# Addendum No. 1

**Project:** Fort Wayne International Airport  
Construct Taxiway G Extension & Demolish Taxiway C2  
AIP No. 3-18-0022-71

**Date:** June 14, 2024

Drawing No.: **X1.1.1**

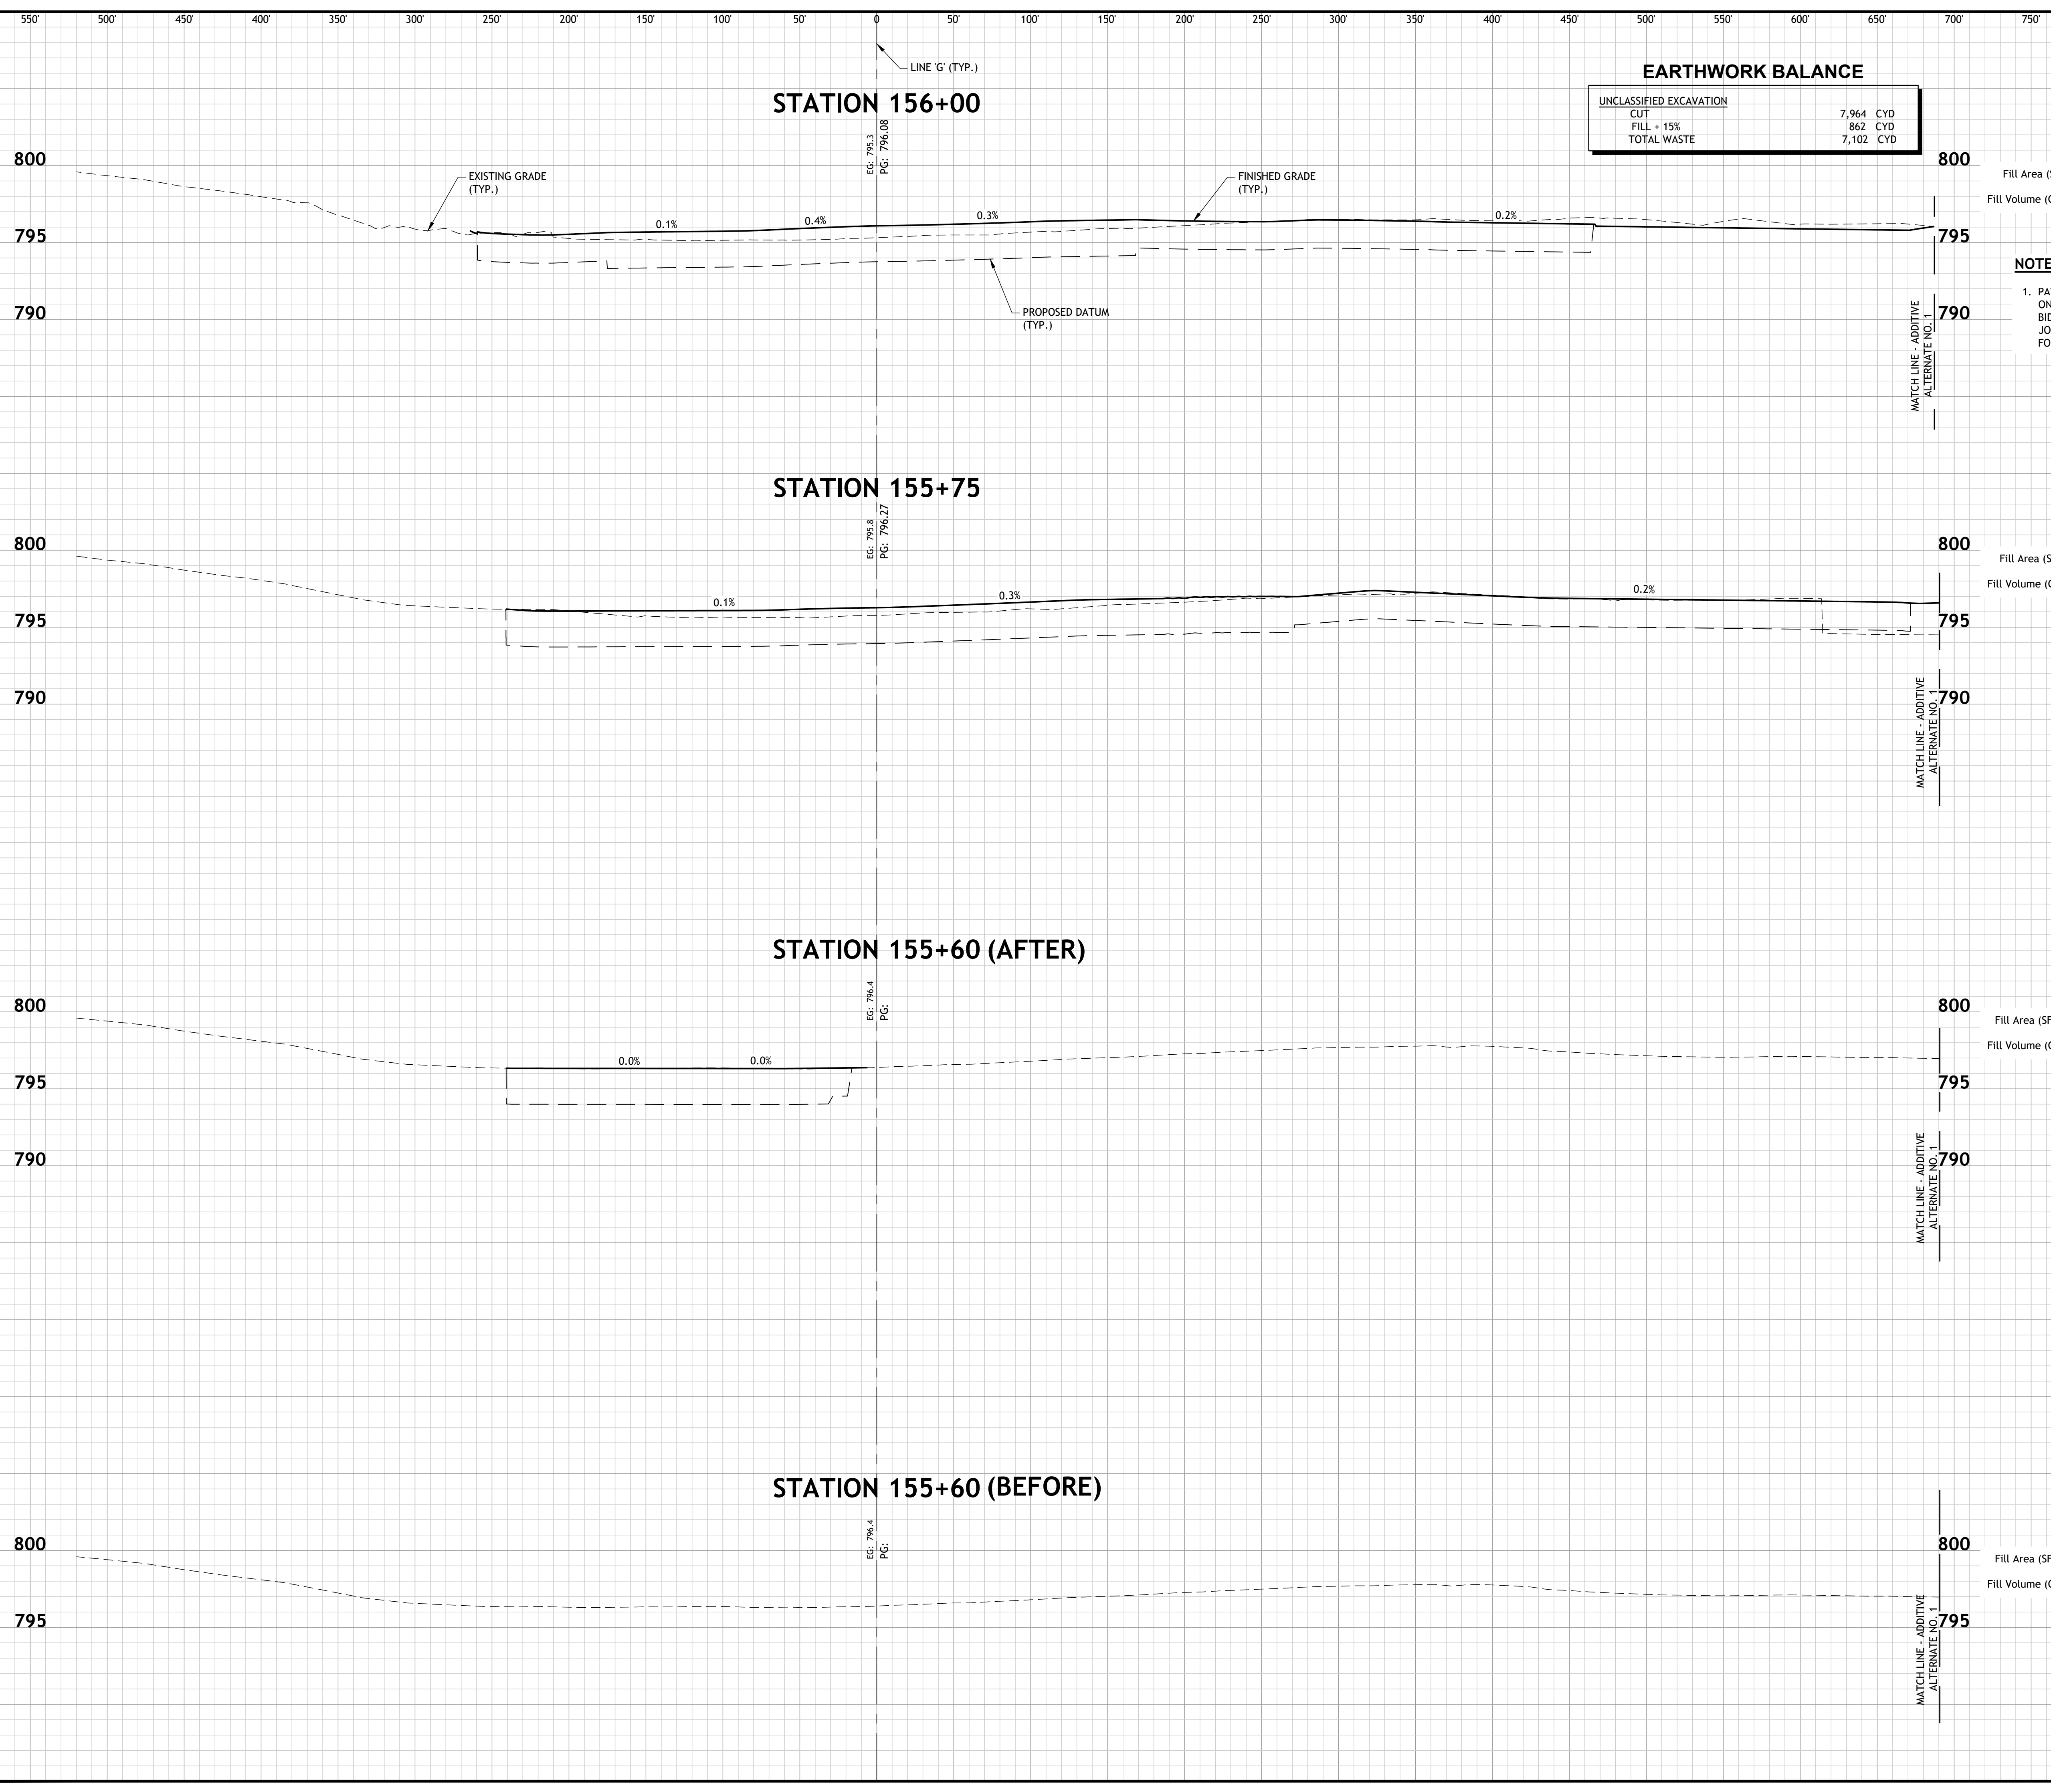
Reissued: Sheets reissued to show updated finished grade and proposed subgrade datum surfaces.

Drawing No.: **X1.1.6**

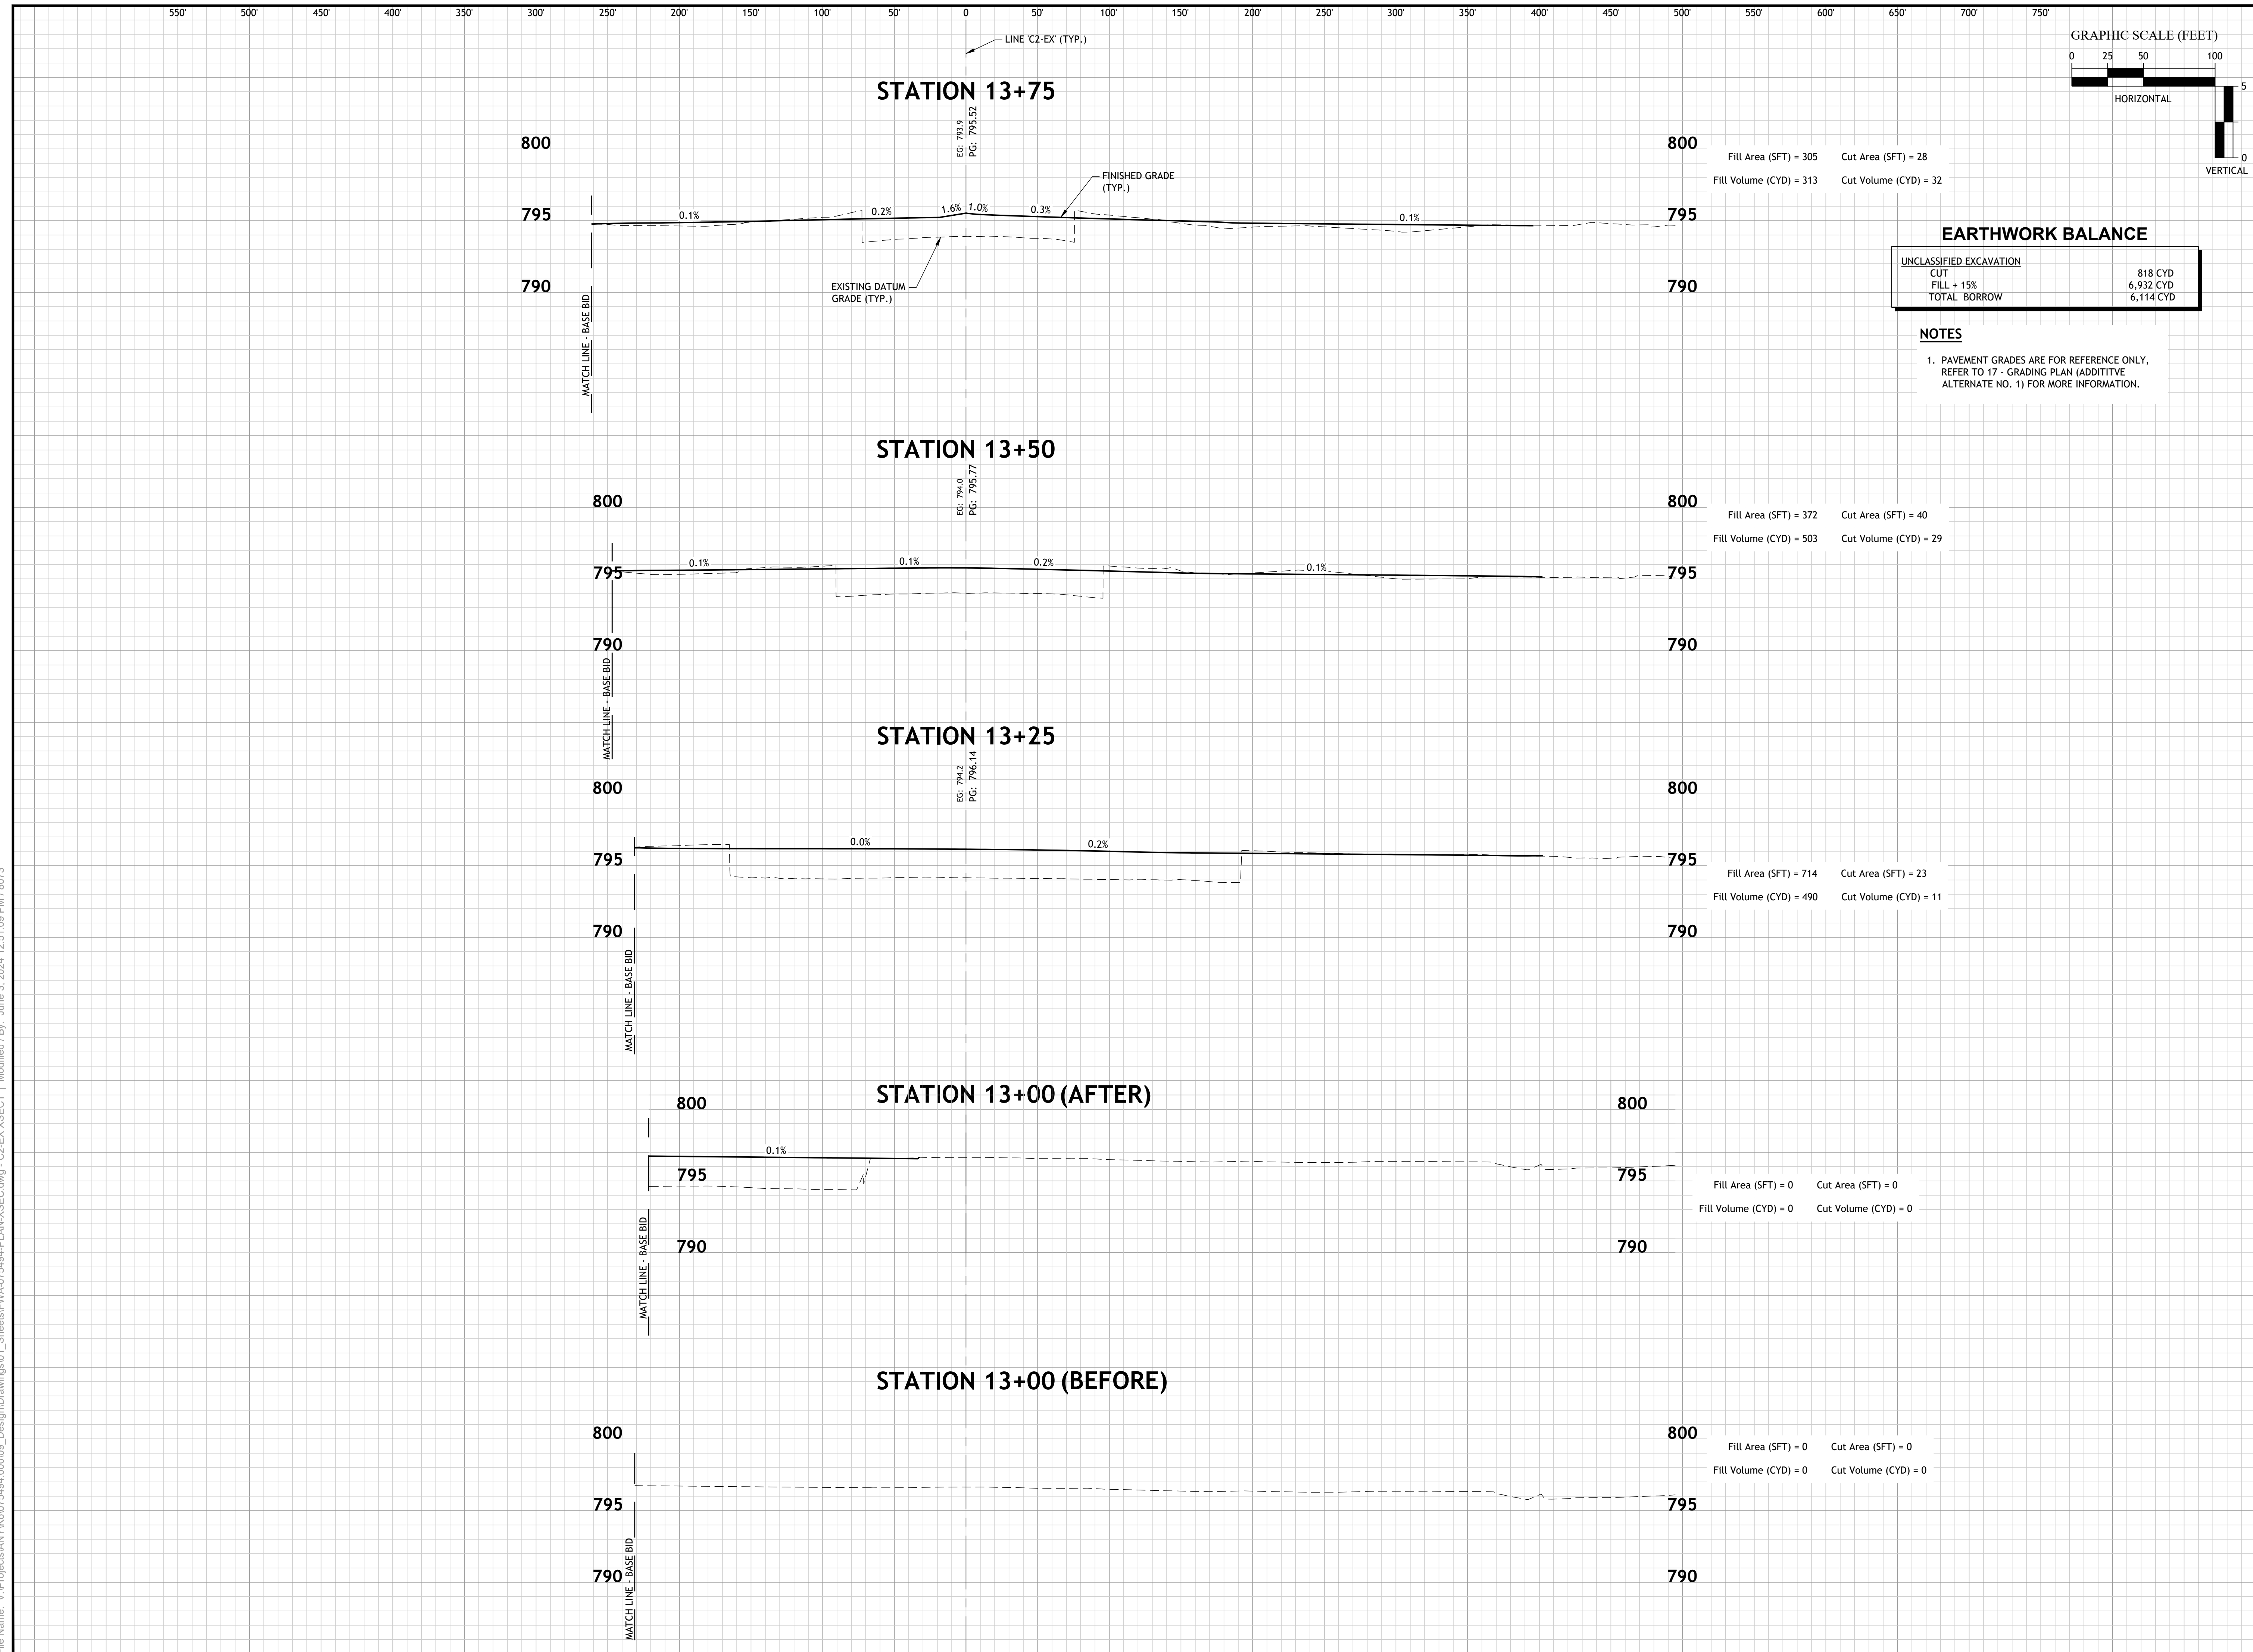
Reissued: Sheet reissued to show updated finished grade surface.
